Agenda - Executive Policy Committee - May 20, 2009

Item No. 6 Zoning Agreement Amendment - 740 Maryland Street / 690 Notre Dame Avenue (Daniel McIntyre Ward) File ZAA 23/2008

RE: Zoning Amendment Agreement and Variance - 740 Maryland (Daniel McIntyre Ward)
File Nos. ZAA 23/08 and DAV 08-152158/D

Appendix “A” – Sketch of nine (9) parking stalls to be deleted

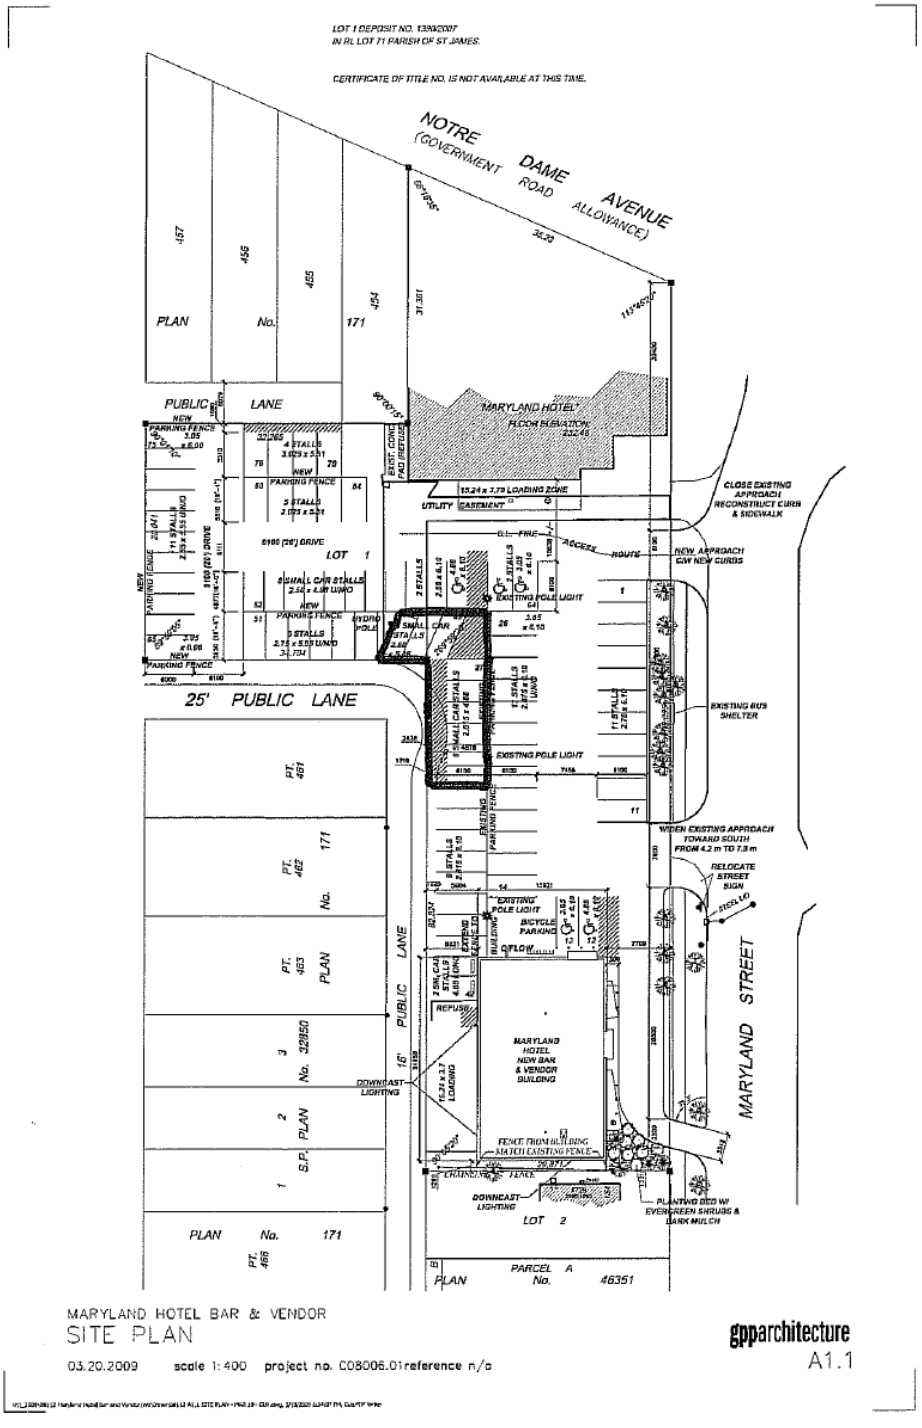
Public Works has indicated that the support this variance, with the exception of the 9 small car stalls at the 90 degree deflection in the lane. (see attached sketch) There comments are as follows:

We would object to the 6 small car stalls abutting the easement, as well as the 3 small stalls in the corner because space is required to accommodate larger turning vehicles at the 90° deflection in the lane.

Small car stalls are generally not well enforced, if at all, by parking lot operators and in this case if larger vehicles are parked in those 9 stalls it may not be possible for garbage/recycling trucks and snow removal equipment to negotiate the turn.

The easement is to provide room for larger vehicles, garbage/recycling trucks and snow removal equipment, to negotiate the 90° deflection in the lane.

iii) That the nine (9) parking stalls outlined in black on the attached Appendix "A" be deleted and that this area be curbed, sodded, and planted with a minimum of 3 deciduous trees, with a minimum caliper of 2.5", to the satisfaction of the Director of Planning, Property, and Development and the Director of Public Works

Consequently, the Division recommends that this variance be approved, provided that the 9 stalls identified in Appendix "A" are deleted, and that this area is curbed, sodded, and planted with a minimum of 3 deciduous trees, with a minimum caliper of 2.5".

Attachment 2 – Sketch plan of landscaped front yard setback

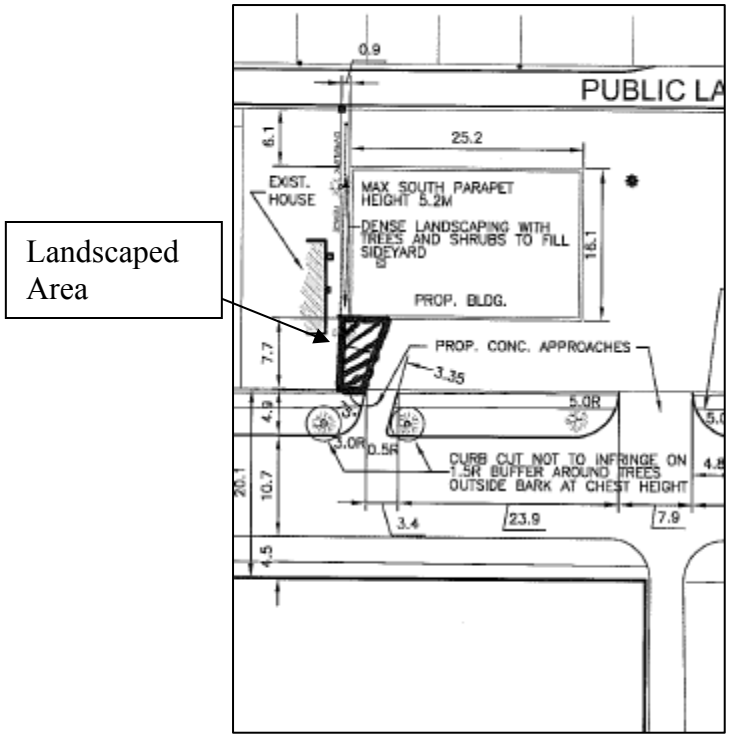
ii. Compatibility with Existing Neighbourhood and Surrounding Uses
A reduced side yard for the vendor building is compatible with the area, provided that the setback is not modified in the front yard (the space between Maryland Street and the vendor building) and that this space is heavily landscaped. (see Attachment 2)

Maintaining the setback in the front yard will provide screening and buffering of the drive aisle and front door, where most of the activity will occur.

i. Side yard
As previously stated, the Division does not have any objections to a reduced side yard for the building. However, it is recommended that a minimum of 4 feet be provided. The applicant is agreeable to this change. In addition, the portion of the yard between Maryland Street and the front wall of the building shall be maintained at a minimum of 10 feet. (see Attachment 2)
